PARK
New Street,
Cambridge **77**

75 NEW STREET, CAMBRIDGE
Special Permit Hearing
September 16, 2014
Package prepared by:
AbodeZ

Response to Planning Board Questions and Comments made at the July 22, 2014 Planning Board Hearing.

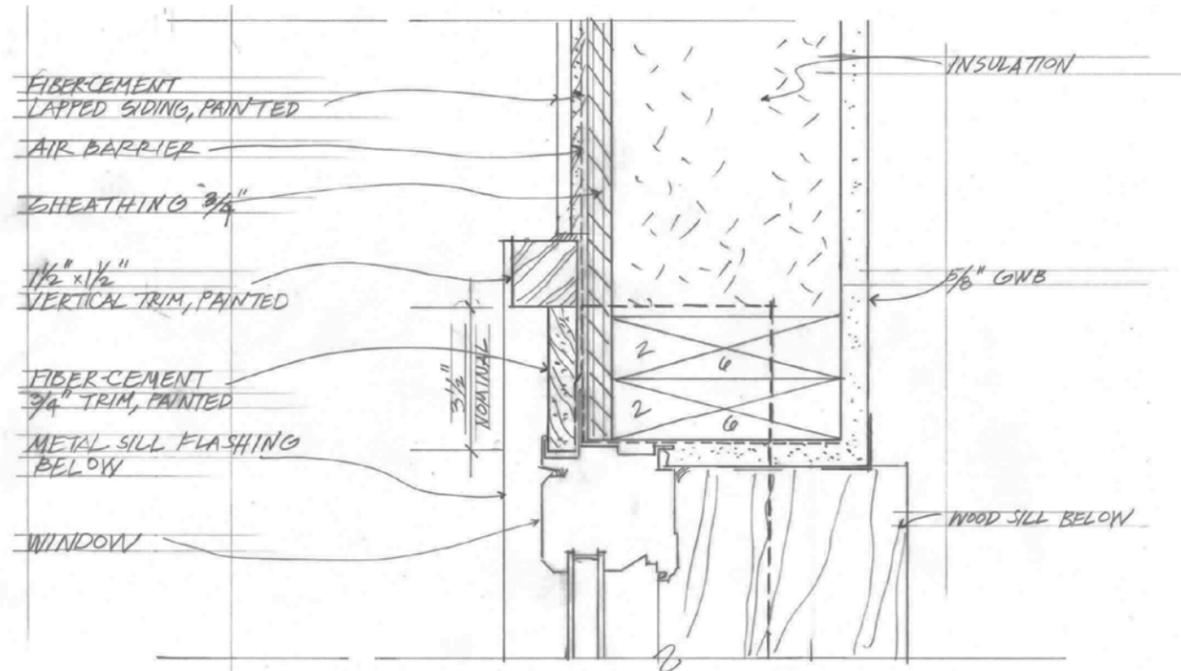
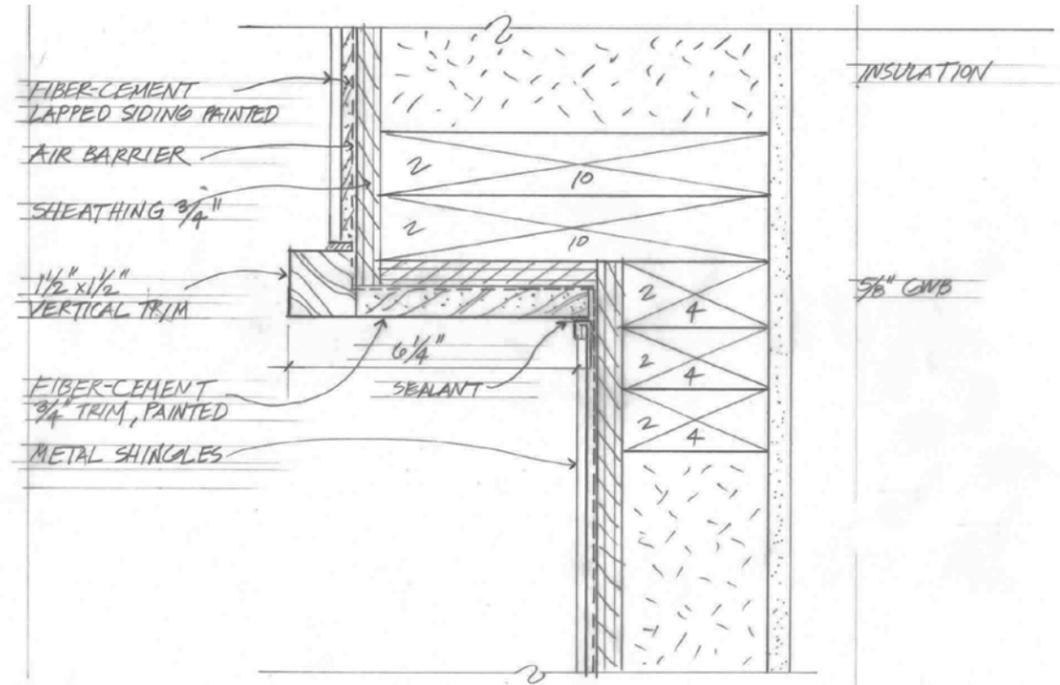
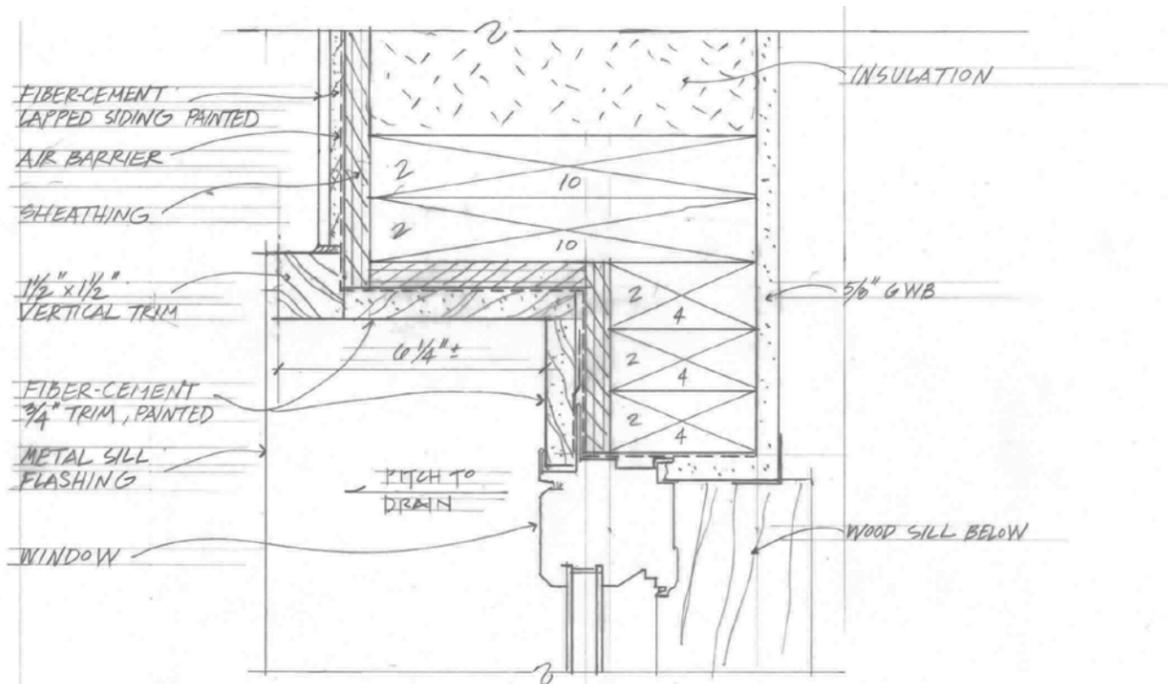
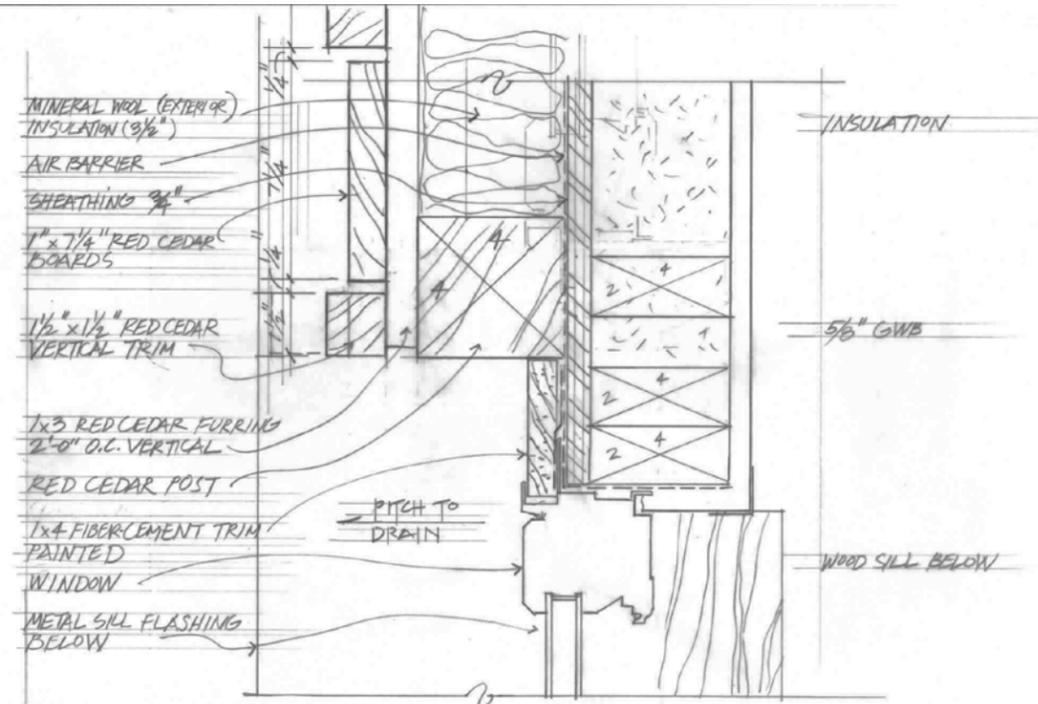
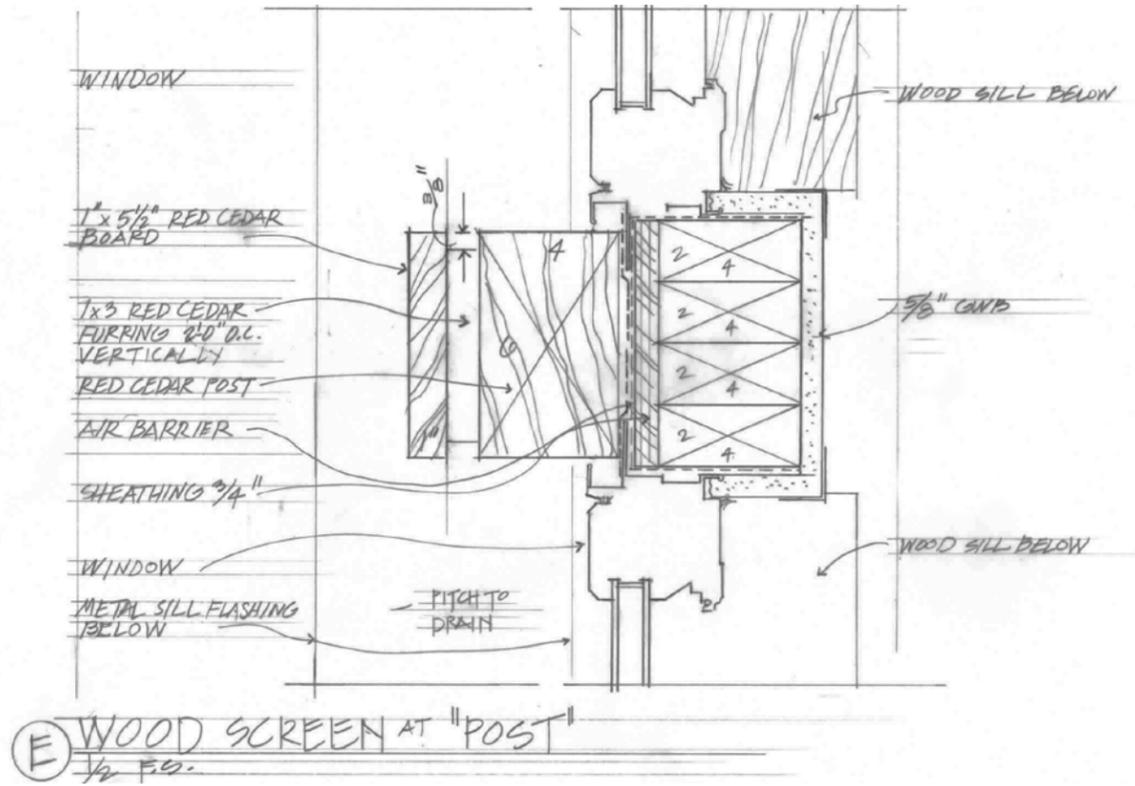
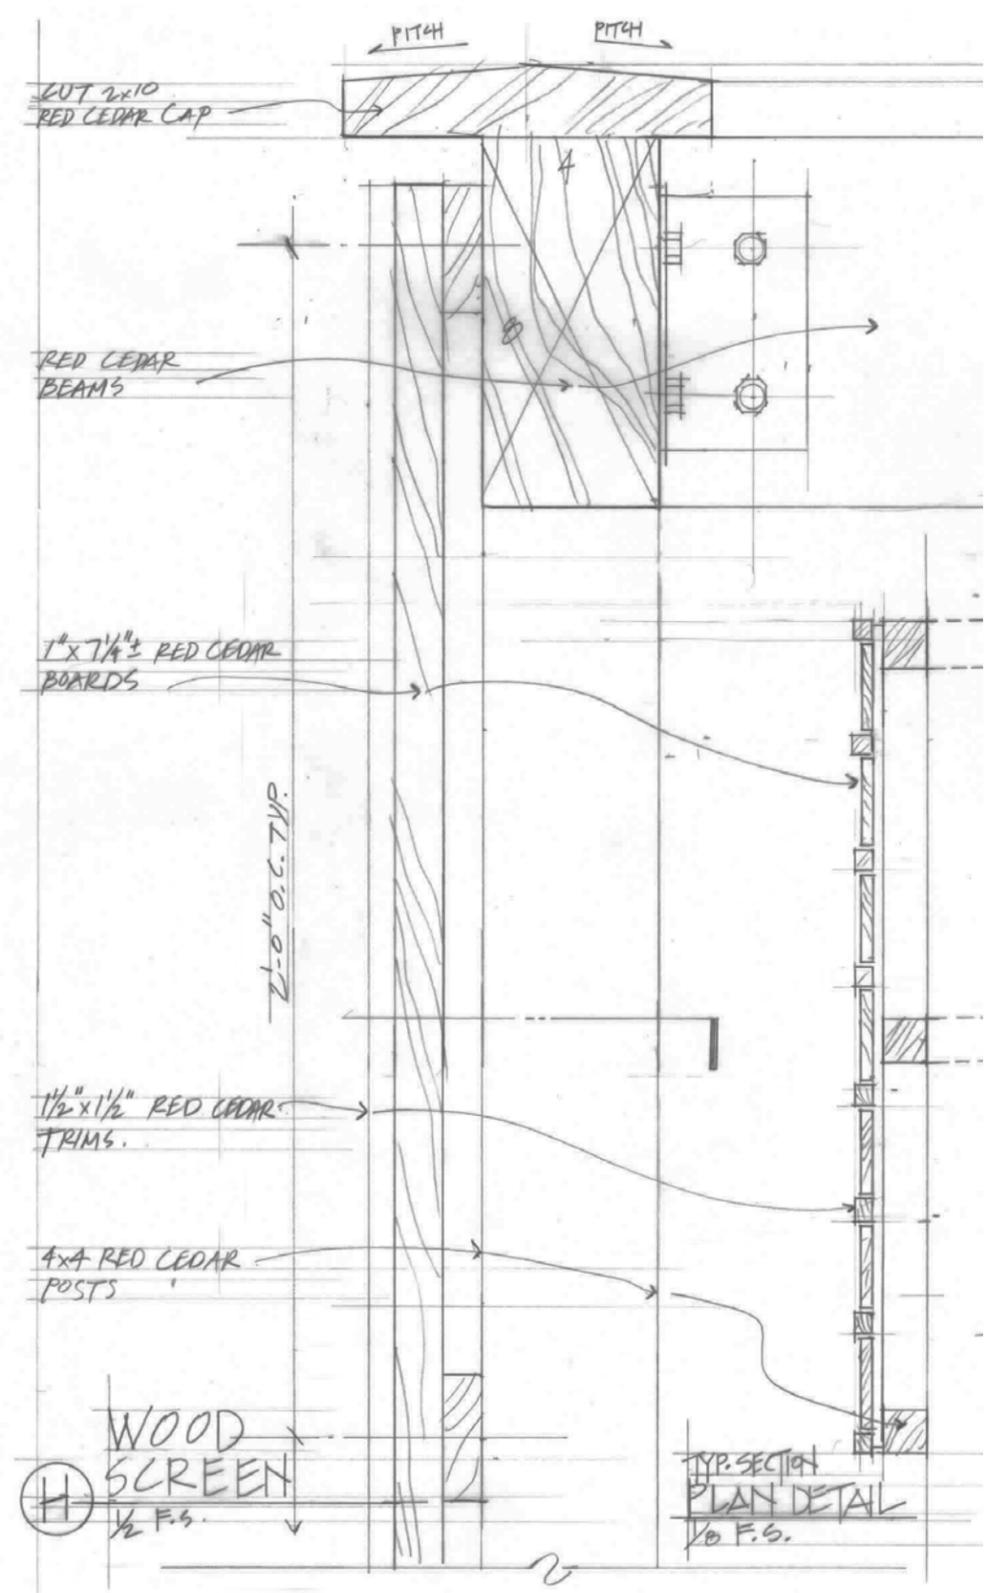
Building renderings are evocative, but there is not enough detail. There needs to be some process for elevation and site plan review with Community Development Staff.

Refer to the attached enlarged elevation and details. Our architects have provided these to show "typical" conditions of the exterior walls, which would be repeated around the building. We will also present material samples at the September 16 Planning Board hearing. We would be happy to

meet with Community Development Staff to review and adjust these details and the site and landscape plans as necessary as the design moves forward.
